PALMER TOWNSHIP PLANNING COMMISSION
AUGUST 12, 2025
7:00 PM
PLANNING COMMISSION GENERAL MEETING

a. Presentation: Traditions of America Proposal

b. Sketch Plan: Chick-fil-A (South 25th Street)

c. Preliminary Land Development Plan: Chrin Southeast Quadrant Lot 2

MAIN ACCESS ROAD UTILITY AND STORM PROFILE

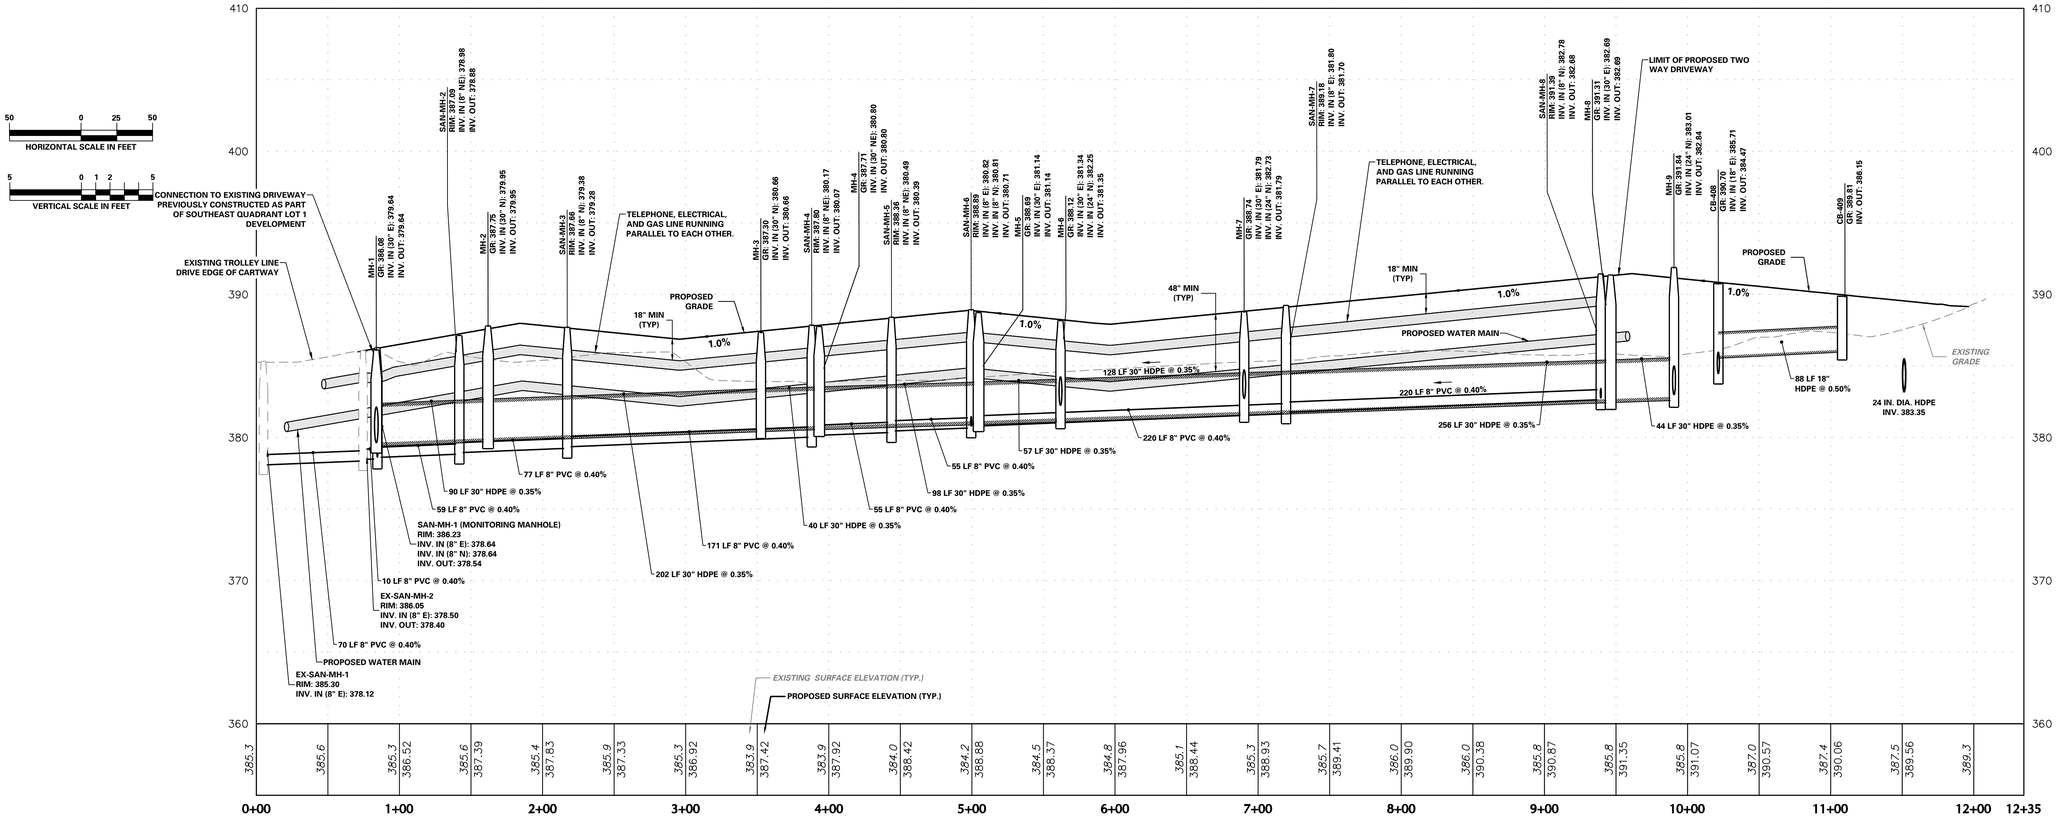
3. Provide vertical curves for roadway profile grade changes exceeding 1% on Sheets 29 and 30. *SALDO§165-59F(3)*

DECIDUOUS TREE PLANTING DETAIL ON 3:1 SLOPE

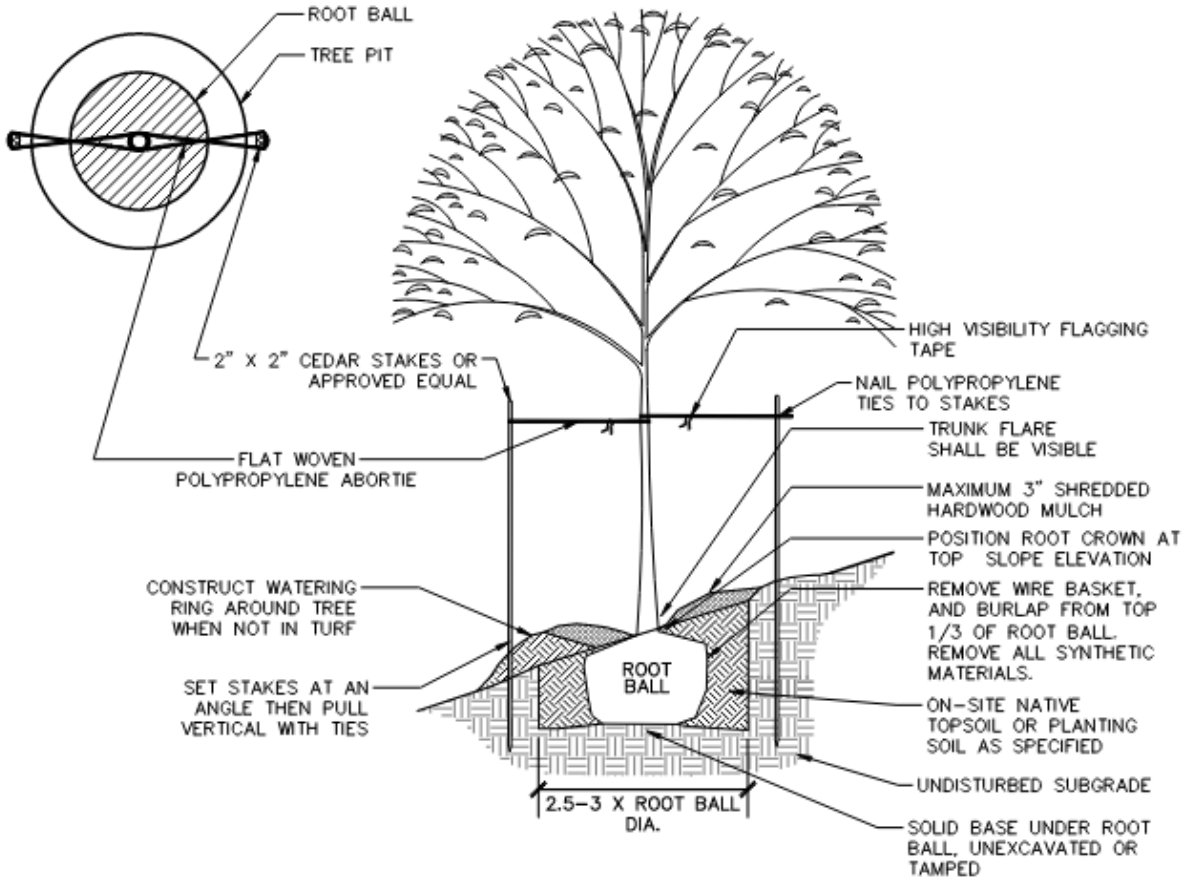
3. **§190-804.D(4)(b)(iii)** – The plant screen shall be permanently maintained. It is noted that the evergreen plantings that are located between Newlins Mill Road and the proposed parking area appear to be placed on a significant slope. Given the slope, and inability to hold water to support the plant material, we question the long-term viability of the plantings and recommend that details be provided to show how these plantings will be installed and maintained. *It is noted that a detail for planting on slopes has been added on Sheet 16. The detail shall be revised to incorporate most current ISA recommendations as shown below:*
